FINAL ENVIRONMENTAL ASSESSMENT FOR THE PIIHONUA-KUKUAU TRANSMISSION MAIN
& RESERVOIR, PUNAHOA 1, PONAHAUAI HOMESTEADS, KUKUAU 1, SOUTH HILO
DISTRICT, HAWAII (TAX MAP KEY: PORTIONS OF 3/2-5-08:24; 2-5-60;, 2-5-35;
2-5-11:04; 2-5-06:61, 142 AND 149; 2-4-75)

Final Environmental Assessment

**PIIHONUA-KUKUAU
TRANSMISSION MAIN &
RESERVOIR**

- A** Archaeological Reconnaissance Survey and Assessment of the
Piihonua-Kukuau Transmission Main & Reservoir
- B** Comments and Responses to the Draft EA

Proposed Alignment in Relation to Flood Hazard Area

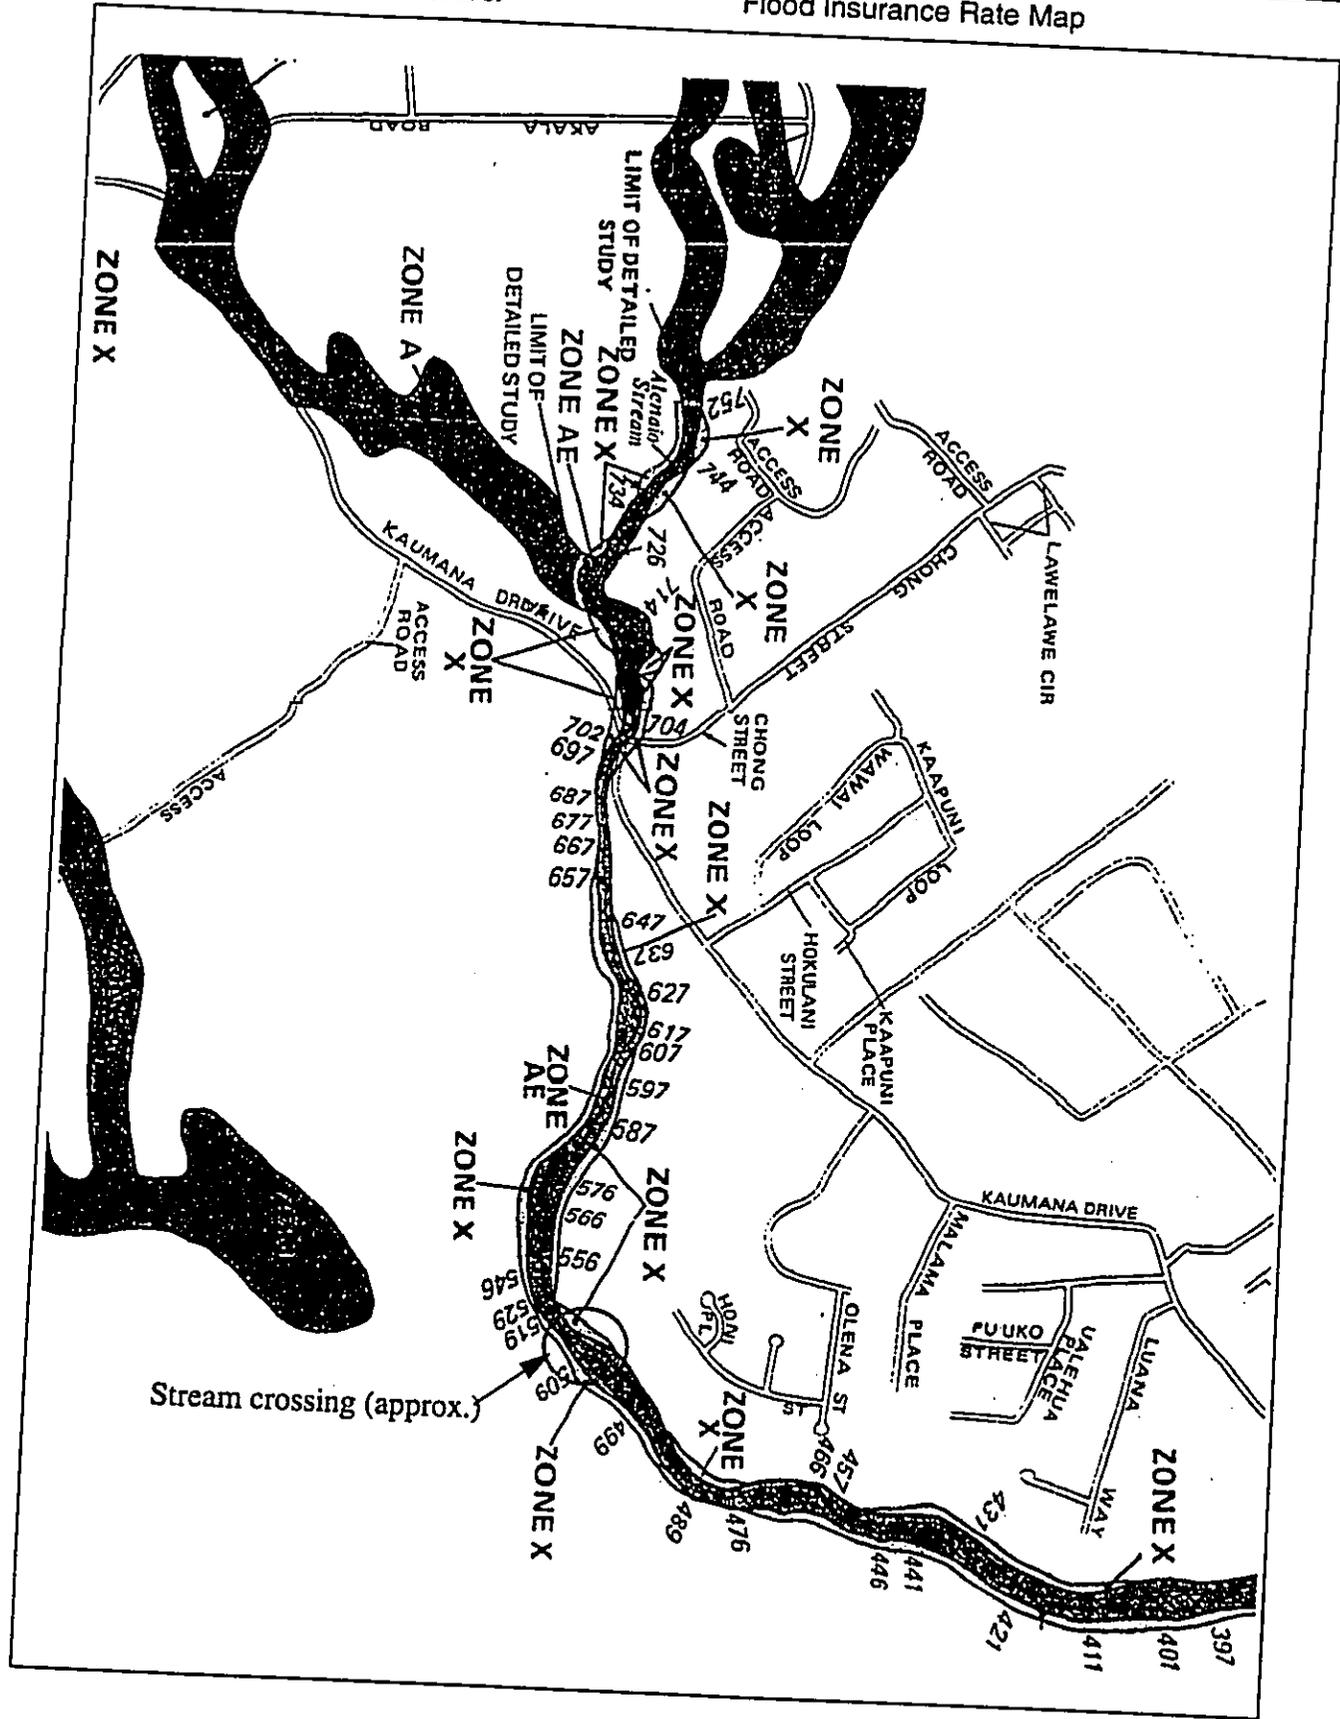
1. Clearly indicate on one of the maps the location of Alenaio Stream and the point at which the proposed main crosses it.
2. List measures planned to mitigate the visual impact of the proposed reservoir. Painting the facility an earth-toned color is recommended.

1. Location of Alenaio Stream Crossing. The Draft EA includes four figures that show the approximate location where the proposed transmission main would cross Alenaio Stream (figures 2, 4, 5, and 6). On one of those figures which shows the special flood hazard area (figure 6), the location of the crossing was specifically identified to show the relevance of the flood control mitigation measures to the project.
2. Visual Impact of Proposed Reservoir. The Final EA incorporates your suggestion to require that the reservoir be painted an earth-tone color to mitigate visual impacts (new §3.1.3 Visual Impacts).

Figure 3. Aerial Photo with Main Alignment Alternatives and Feature Locations

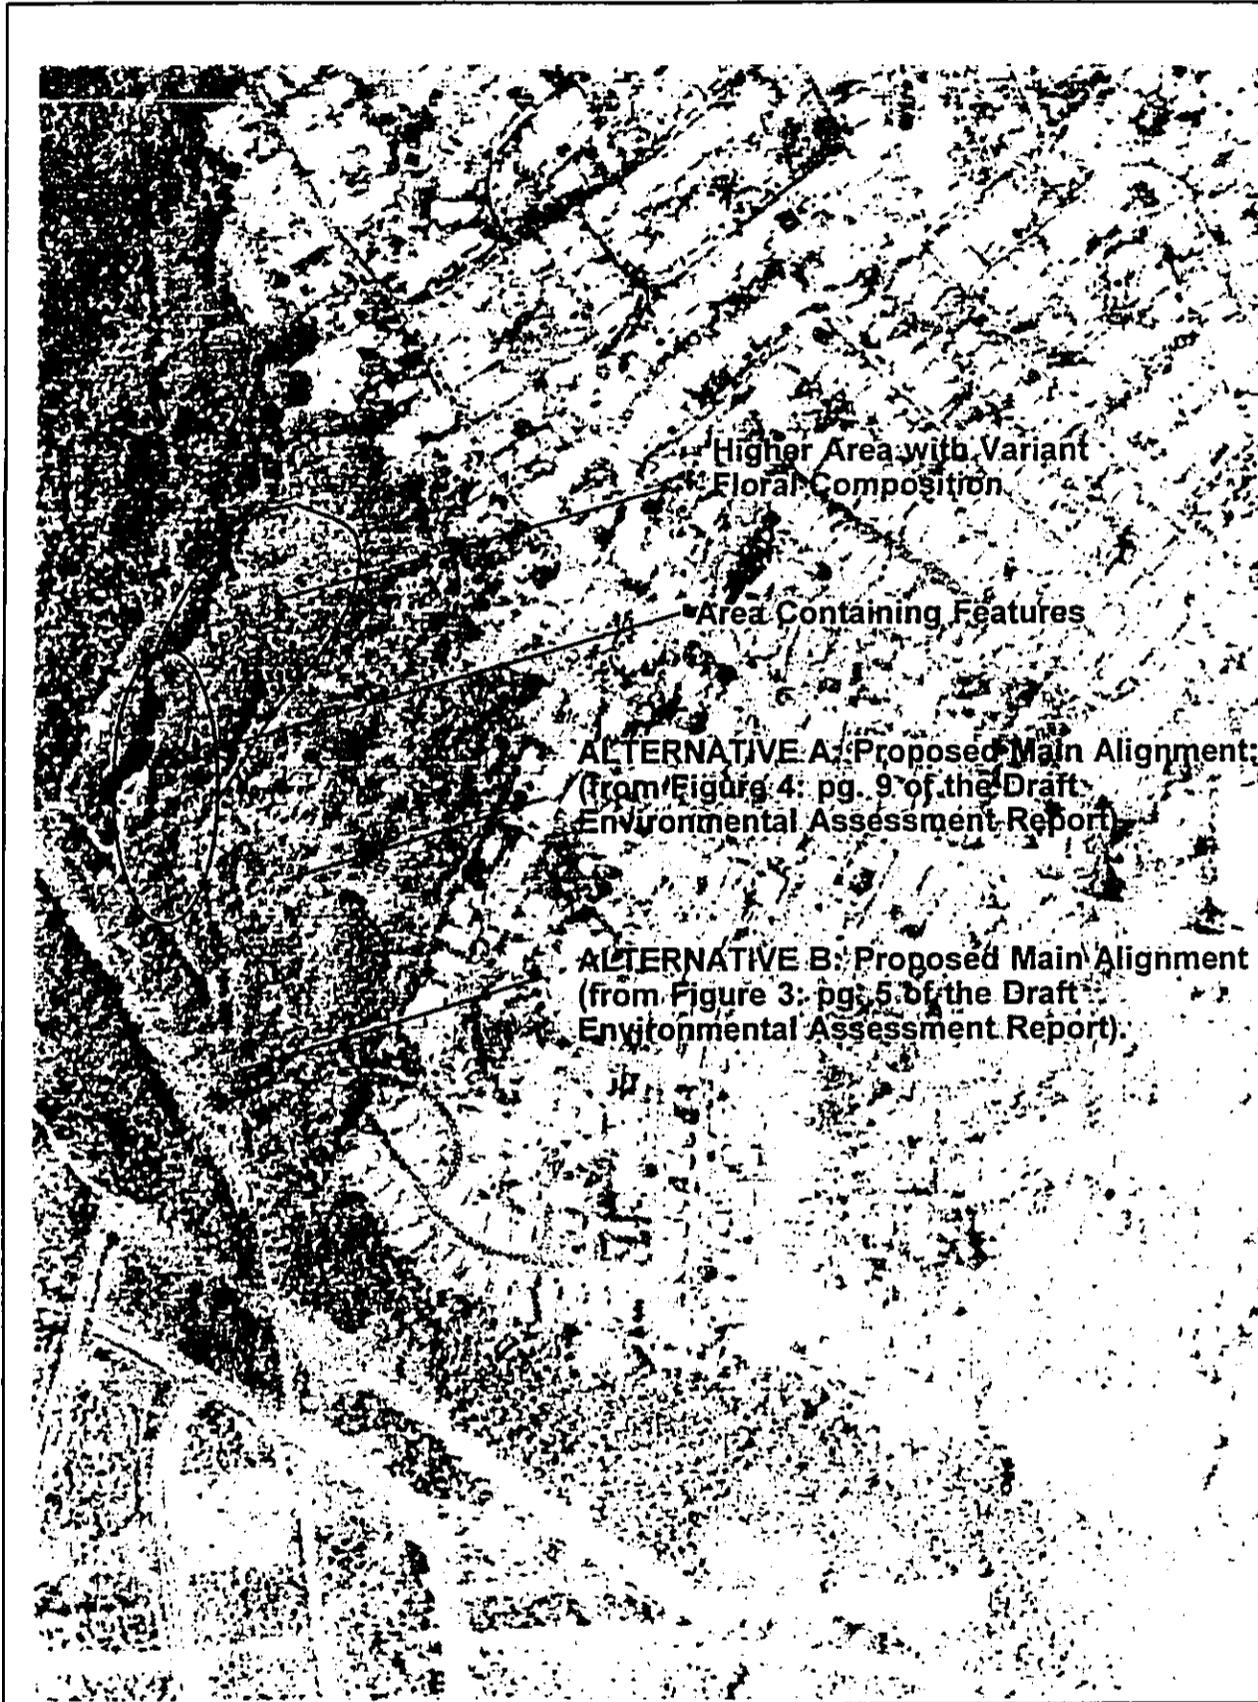
As you know, we do not review reconnaissance survey reports because they do not meet minimal standards of our office for archaeological surveys. The survey, which was undertaken in response to our initial review of the proposed project (letter dated June 25, 1996 from Hibbard to Uchida), does appear to have been successful in determining the presence/absence of historic sites in different sectors of the proposed transmission main. It is our understanding that no evidence of historic sites was found in either of the two alternative alignments of Sections 1 and 2, but that there are some stone mounds/platforms in Section 3. According to the letter from Mr. Takemoto, the Hawaii County Department of Water Supply will ensure that the selected alignment avoids the historic remains in Section 3. This avoidance would result in this project having "no effect" on significant historic sites. If realignment is not possible, then impacts to sites seem likely to occur, and we would require an archaeological inventory survey of Section 3.

Though we have already said that we do not review reconnaissance survey reports, a State site number should have been assigned to what you found and described. Since all of the remains are clustered in one area we think you could use just one site number. Please contact our office to get a number. Minimally, use of this site number would require an errata sheet be sent to our office and to your client to go with the report. Ideally, the report could undergo some minor revisions in the text and illustrations to include this number. We would suggest the latter

Therefore, we present this errata sheet in order to assign state site number 50-10-34-21145 to these ten structures.
